MEMO

**Re: Response to Public Consultation Comments and Suggestions Regarding
Upper Bench Options for Highway 29**

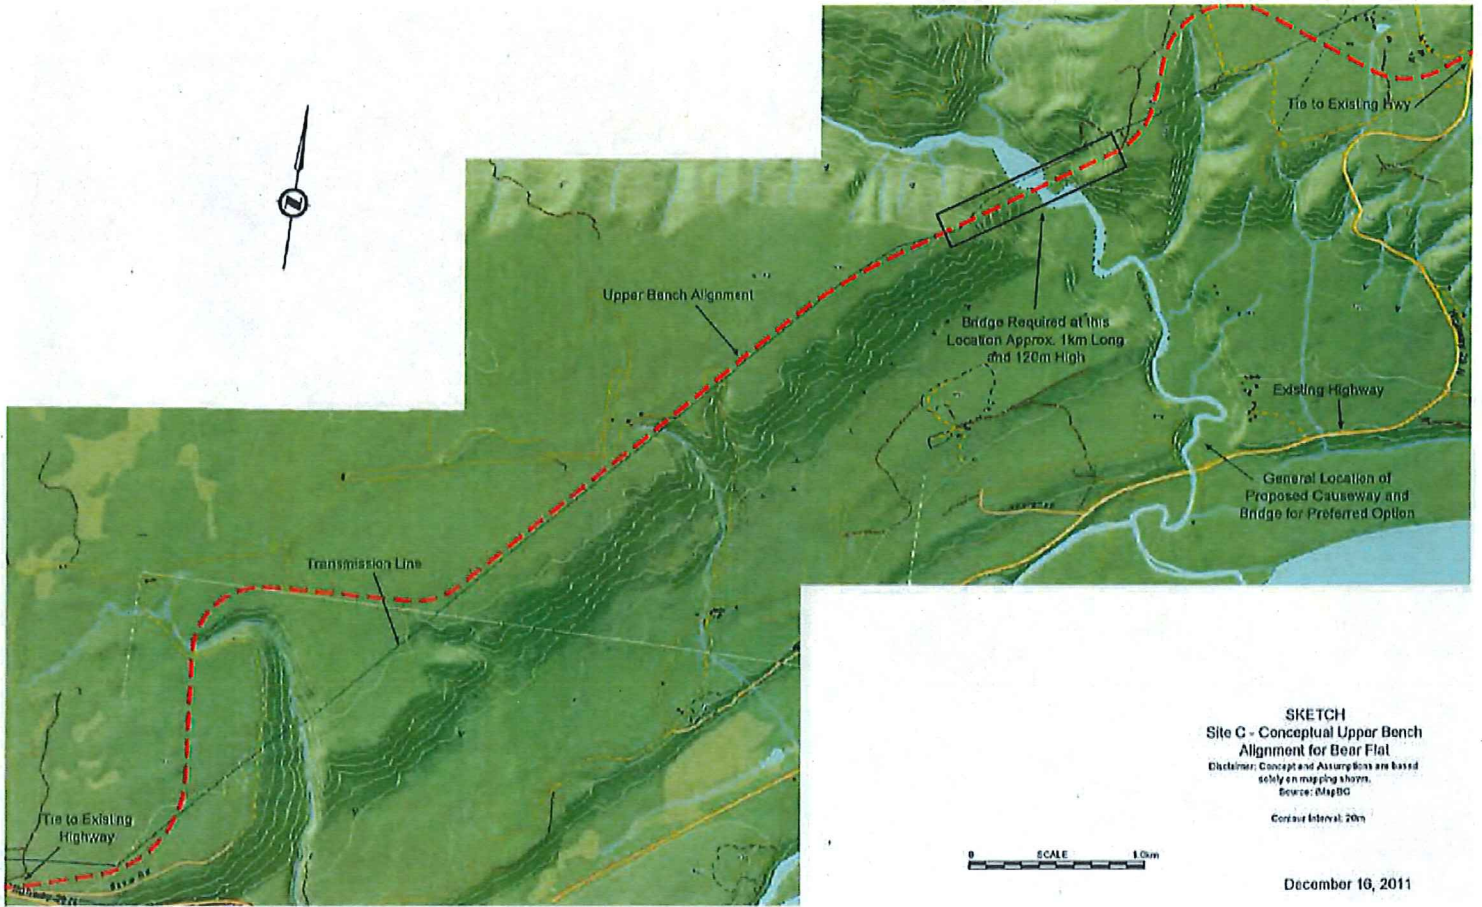
3 & 4: Alternative Alignments Utilizing Existing Roads off Highway 97 North of Highway 29

The attached sketch shows conceptual routes along existing roads from "Mile 68" and "Mile 95" on Highway 97. These options are evaluated herein at a conceptual level to corroborate the Urban Systems report and determine if further investigation is warranted.

- o The routes shown are not continuous and will require non-existent connections and river crossings.
- o It can be expected that significant portions of existing road alignments will not have road geometry meeting design speed (highway) requirements.

- o Even in areas where existing road geometry may be adequate for the proposed design speed, it is expected that substantial reconstruction of the road base, river crossings, and drainage works will be required to meet the highway design criteria, including roadside clear zone.

- o Geotechnical information for the alternative routes is not provided but it is expected that substantial hauls for granular materials for road base and paving will be required from limited sources in the region.

- o It is expected that all-season access to inhabited areas along the existing Highway 29 will need to be provided and/or maintained.
- o The table below provides a concept cost comparison between the base case (Highway 29 relocations and bridges) and alternative routes.

- o The alternatives are substantially more expensive than the base case based on new highway construction alone. The provision of access to the isolated areas of Highway 29, and consideration of user costs further increase the cost differentials. Consideration of maintenance costs would also increase the cost differentials. Consideration of property costs would not affect the fundamental result of this evaluation. The comparison is not sensitive to unit costs; similar results are derived using a range of unit costs.

- o Significant increases in travel time between Hudson's Hope and Fort St. John, and points in between, will result.

Conclusion: Within the objectives of the Site C project, there is no justification to further explore the relocation of the Fort St. John to Hudson's Hope connection via these alternative routes. These alternatives will be substantially more costly, effect a larger environmental footprint, and impose significant costs and time on existing road users.

SKETCH
Site C - Conceptual Upper Bench
Alignment for Bear Flat

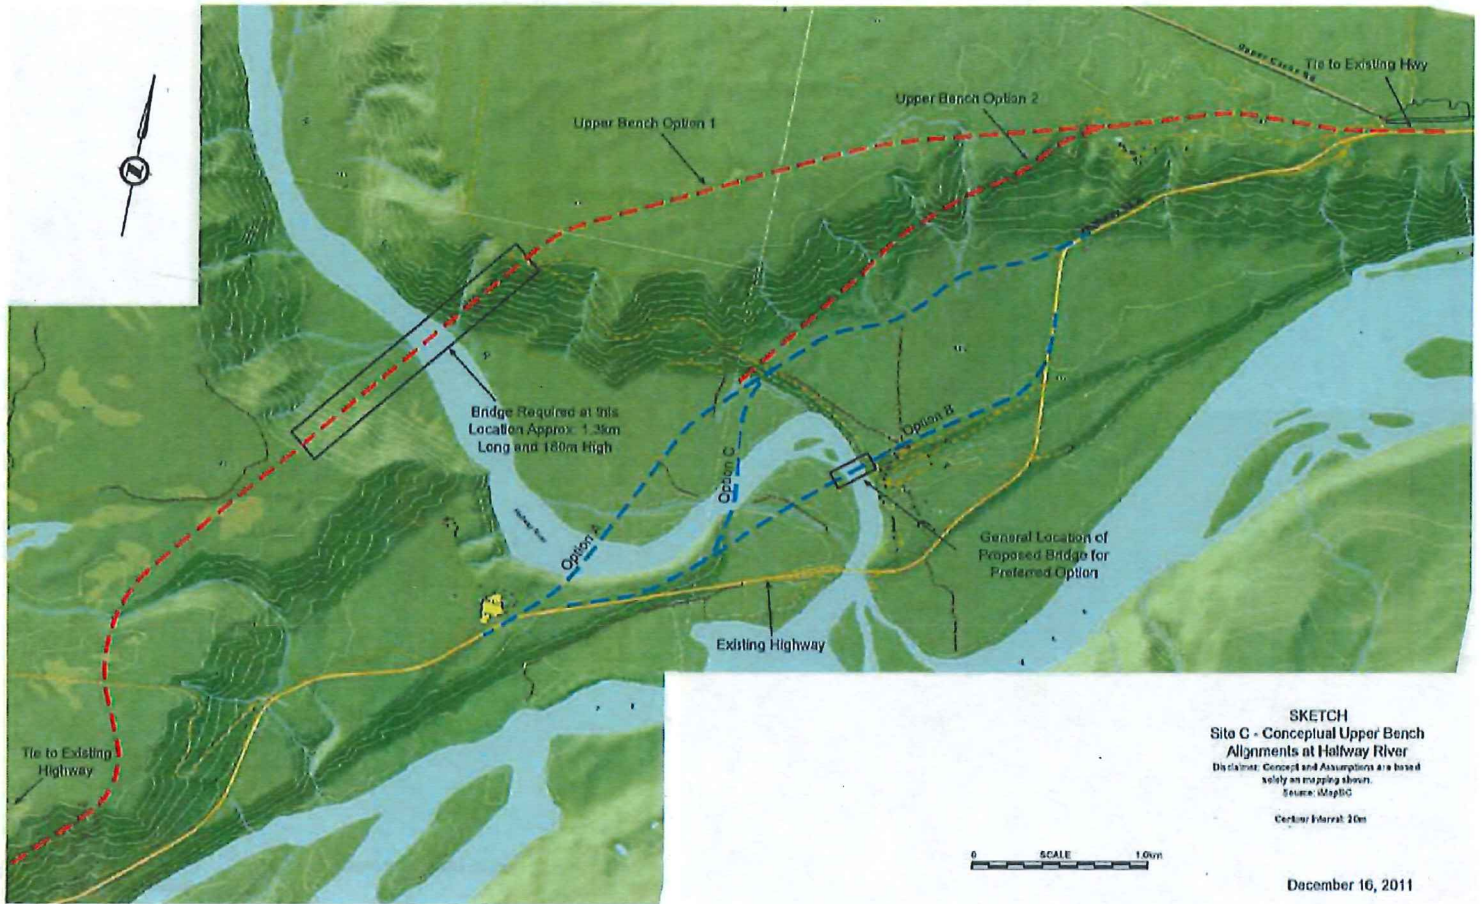
1: Bear Flat – Alternative Alignment at Top of Bench Along Transmission Line

The attached sketch shows a conceptual route along the bench above Bear Flat. Similar to the alignment in the Urban Systems report, the route would generally follow the transmission line, but would divert around larger gullies where possible.

- o In addition to being longer than the proposed option, the alternative route faces the additional challenge of crossing the Cache Creek valley at a much higher elevation.
- o This would either require a very large bridge on the order of 1km long and 120m high, or a smaller (but still very large) structure might be possible by routing the highway down into the Cache Creek valley. Routing the highway down into the valley may not be possible with geometry maintaining the 90 km/h design speed, and would entail very large earthworks on slopes which have been characterized as unstable silt.

- o The following table summarizes a conceptual cost comparison for the bridge options and shows the very large cost differential between the two options. Excluding the bridge crossings, the upper bench option would still cost on the order of 40% more due to the length of new highway needed and the requirement to provide access to the properties on Bear Flat.

Conclusion: Based on the above, the upper bench option does not warrant further investigation because the additional cost cannot be justified.
